New switch for power windows

Background

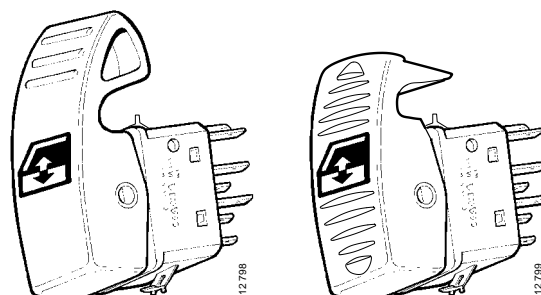
The power window switch has a return spring. This is located behind the black switch button.

When the driver climbs down from the cab he may catch on the power window switch and the black button may be forced loose. The spring behind the plastic switch also falls out and is lost.

In order to remedy this problem, a new shorter switch has been introduced into production from the following chassis numbers:

Designation	Outgoing part	New part
Switch	1 368 831	1 413 146
